**Technical Support for TPCR4 Rollover
Assessment of Non-Load Related & Load
Related Capex.
Initial report - NGG**

London, April 06, 2011

By order of Ofgem

Figure 13: Sketch of the Humber Crossing tunnelling, solution to eliminate risk regarding strong currents on the Humber estuary
(Source: NGG presentation 2011)

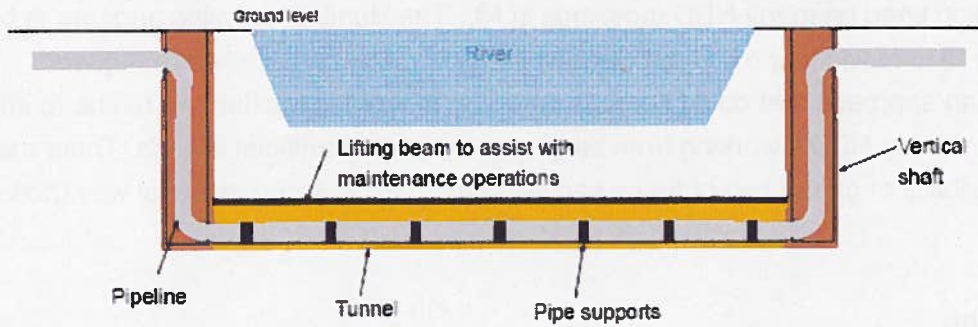
The general approach adopted by NGG appears to be consistent with best practice for such one-off problems, although the level of detail pertaining to each of the four options differs and, in particular, the option of lowering the existing crossing has not been considered, nor have options for self lowering (which is an offshore practice) been considered. The main alternatives that have been considered are discussed below:

A critical issue for all of the feasible options is the need to comply with planning requirements and, in particular, once options have been consulted upon in the pre-planning phase, whether the tunnelling approach will be acceptable to the Independent Planning Commission (IPC), subject only to limited further consultation, but without further consultation on all other options. This creates an uncertainty as to whether the more significant expenditure identified for the Rollover year will actually be incurred, or whether, as a result of the need for further consultations and Planning Act activity, this spend is delayed.

However, the critical issue concerns the timing of the expenditure, whereby the initial design work and site investigation is anticipated to commence in the Rollover year, at the proposed cost of [REDACTED] with the subsequent work to install the tunnel occurring in subsequent years. The planning for the proposed investment in the Rollover year can be discussed in terms of the urgency of the problem. At this moment there is no serious free span and possible vortex shedding. This current plan is based on the assumption that the pre-planning work being undertaken by NGG will lead to avoidance of the scheme being classified as a Nationally Significant Infrastructure Project (NSIP) under the recently introduced Planning Act. But this is a relatively new process that is being progressed and there is a risk that the design options will require further assessment and consultation before consent is given. On this basis it is considered that the proposed expenditure may not be feasible in the suggested timescales and KEMA proposes that this element of asset health NLR can be deducted from the allowances.

Figure 14: 4 examples of alternative routes for the Humber Crossing

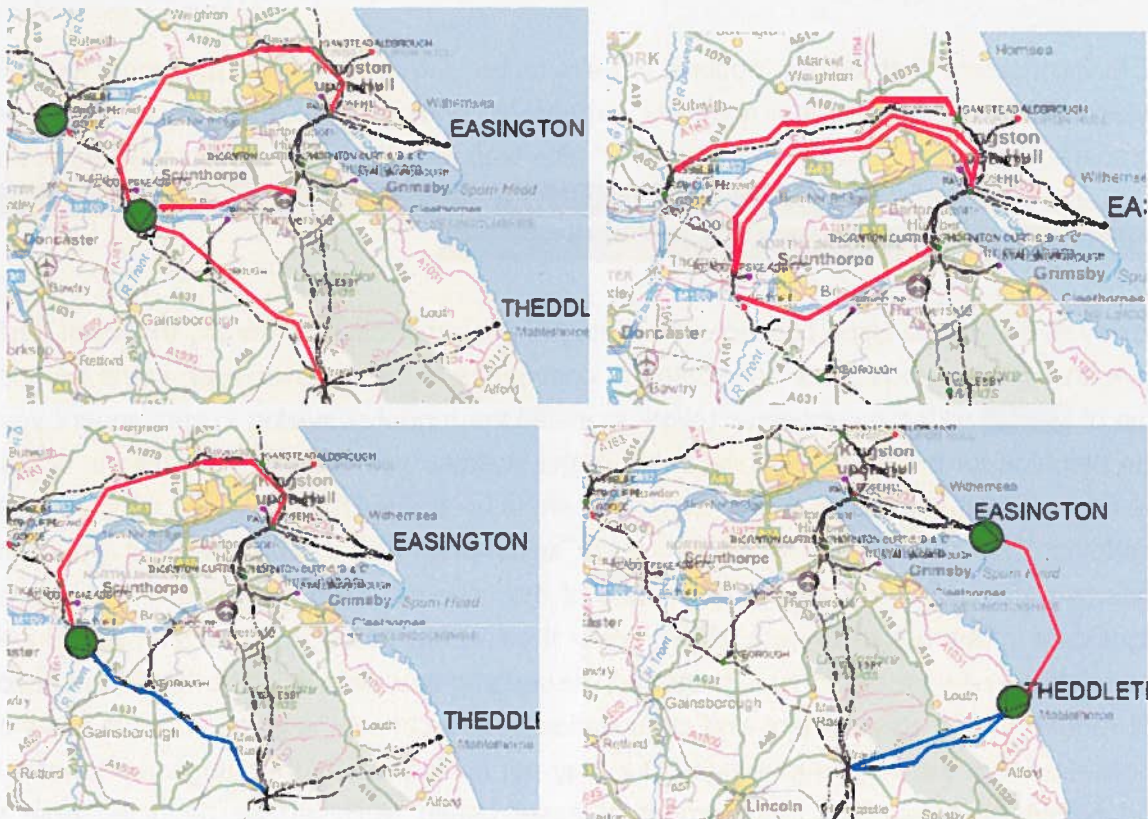
These have been extensively investigated and a number of examples are presented in Figure 14. It has been concluded, however, that due to the longer distances and pressure drops, none of the alternatives are considered feasible. [REDACTED]
